CPCC ENGINEERING PACKAGE

EP No: ECR-25-000862 Rev 00

EP Title: Replace 400A Water Tank Heaters Q39 and Q41

WAS: ZONE E6

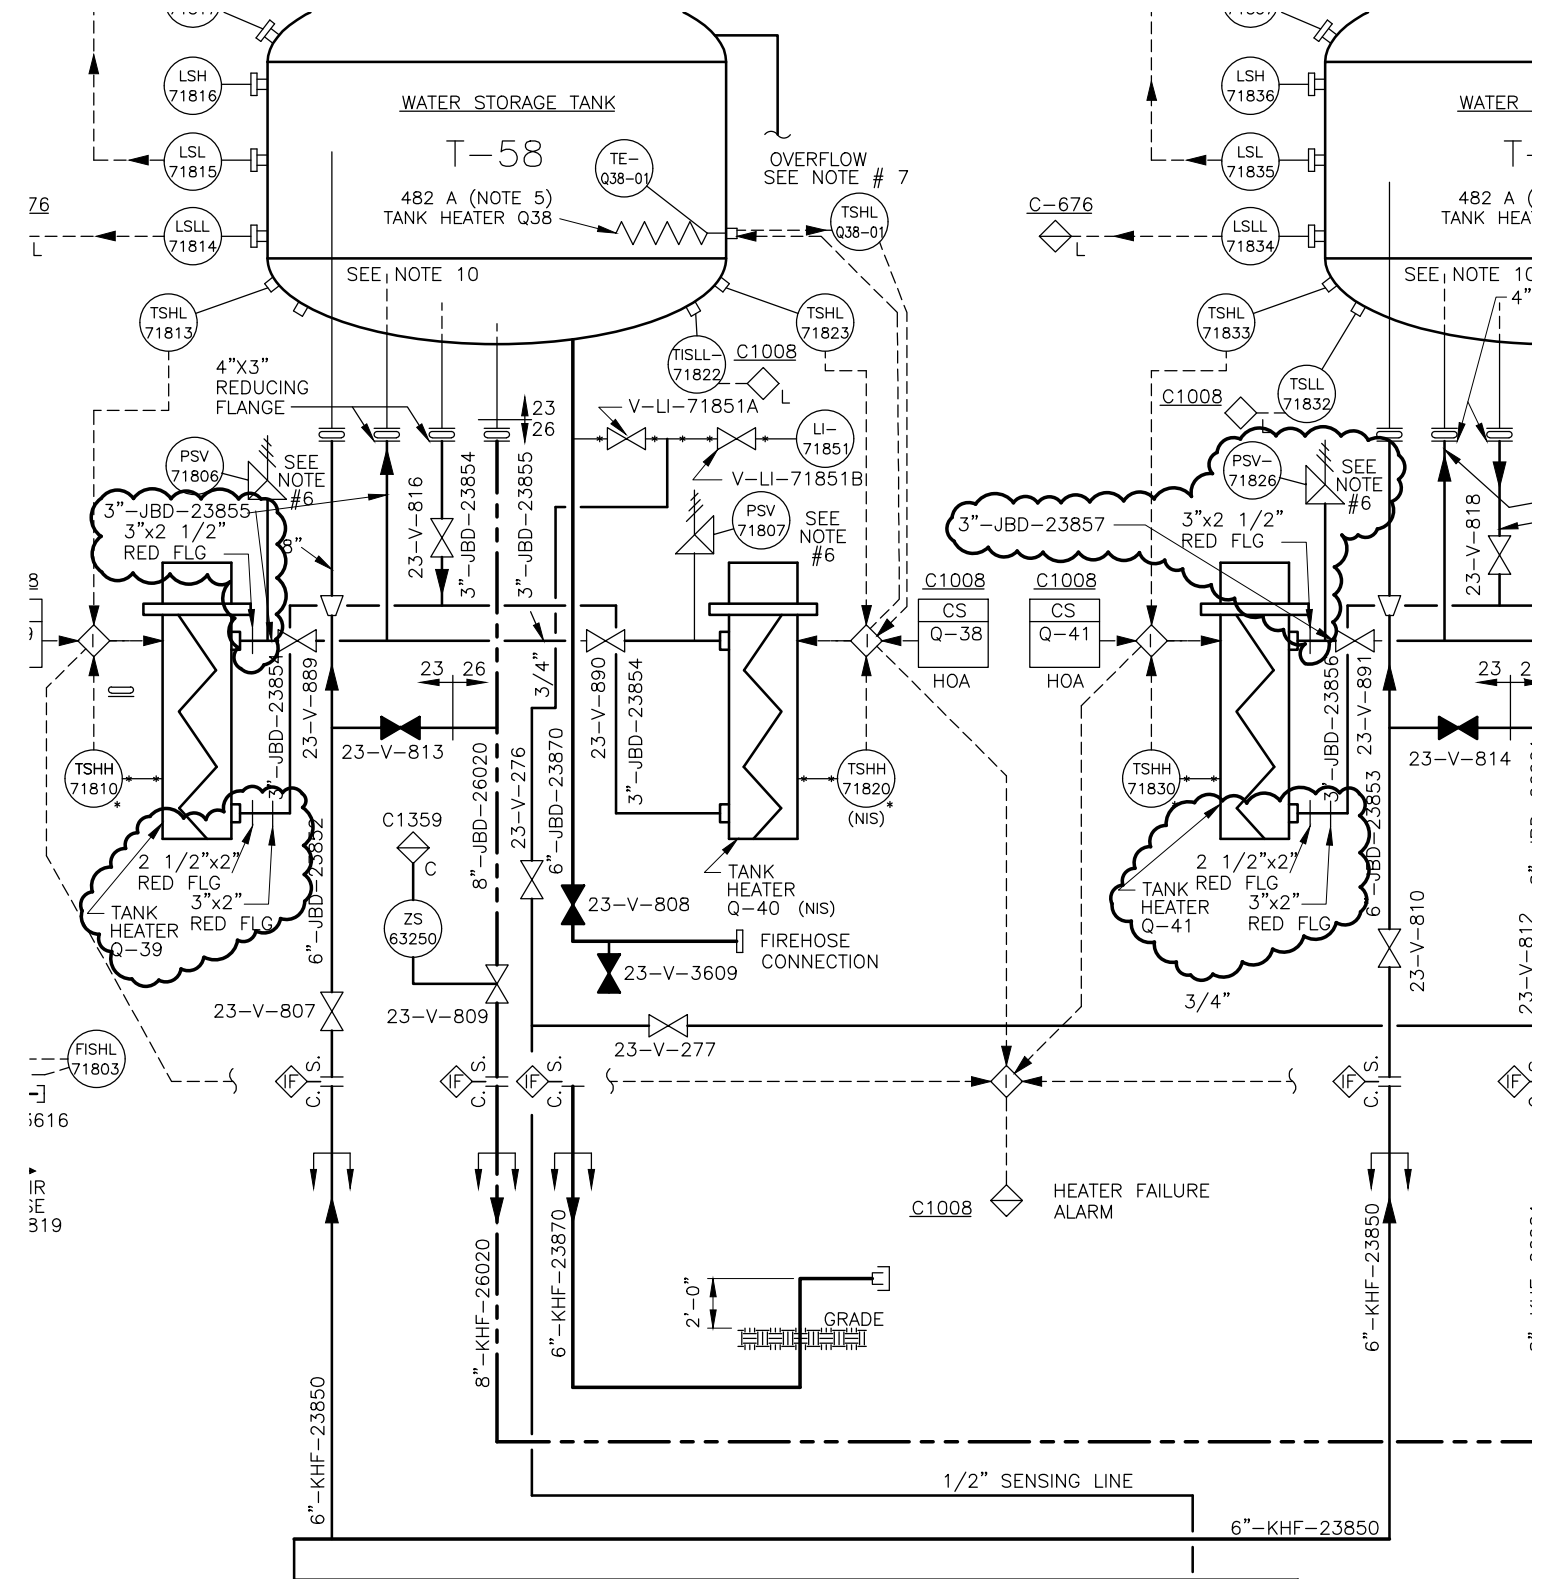
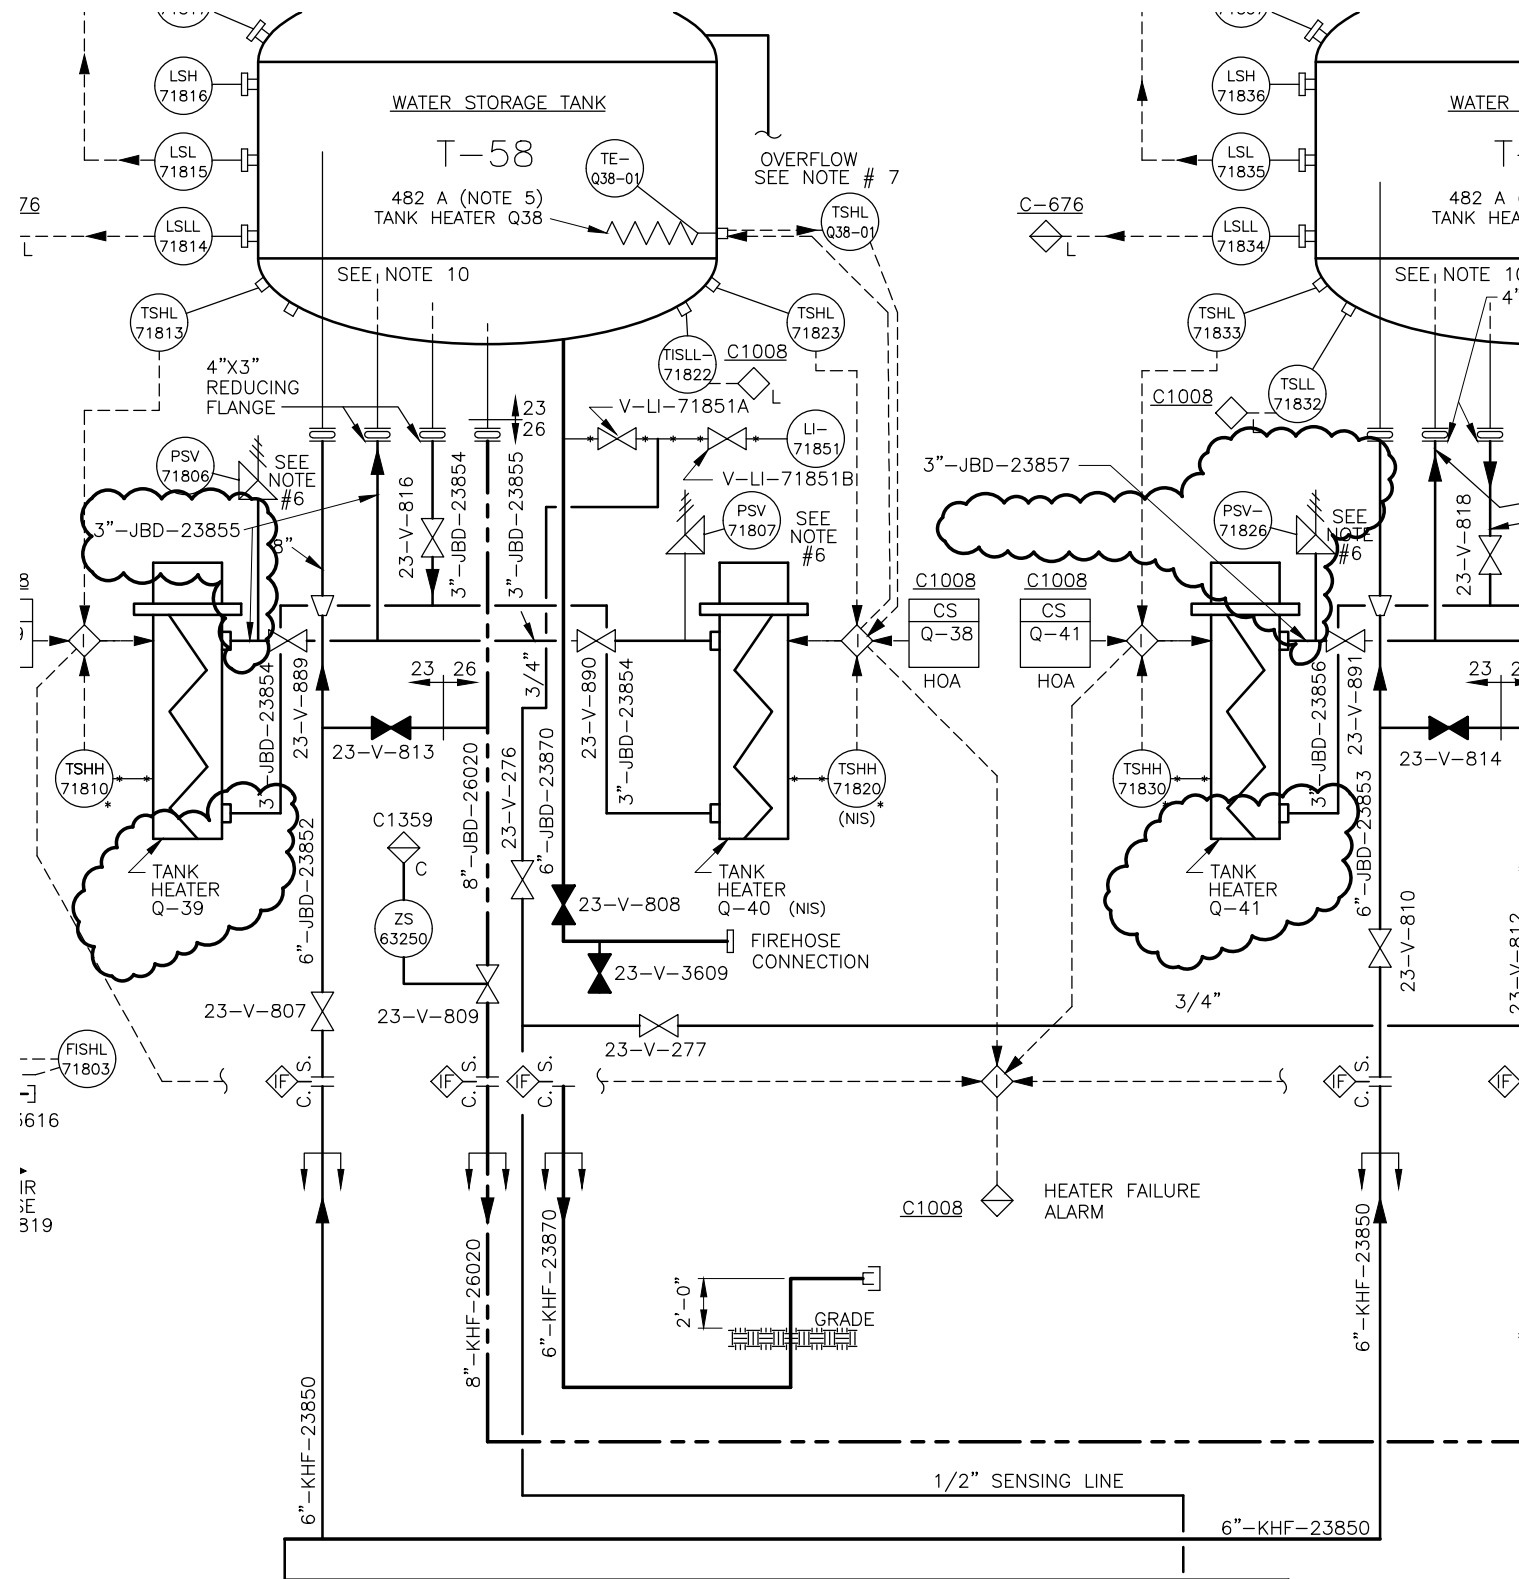
Change Description and Scope:
 The current water tank heaters Q39 and Q41 will be removed from water tanks T-58 and T-87, and replacements will be installed. The current heaters have 3-inch inlet/outlet, the replacement heaters have 2-1/2-inch inlet/outlet, reducing flanges will be installed to account for this. The current heaters are 47-1/4-inches from inlet to outlet; the replacement heaters are 52-inches from inlet to outlet. At the inlet, a piping assembly (see Sketch-02) including a reducing flange (2-1/2 x 2), 2 90-degree elbows, 3 fully threaded pipe nipples, and a second reducing flange (2 x 3) will be utilized to accommodate the 4-3/4-inch difference in inlet to outlet dimension from the current heaters to the replacement heaters. At the outlet, a piping assembly (see Sketch-02), including a reducing flange (2-1/2 x 3) and a 9-inch pipe nipple will be utilized to accommodate the dimensional difference created by the new piping configuration at the inlet. Replacement heaters will be installed in the same orientation as the current heaters (see Sketch-02).
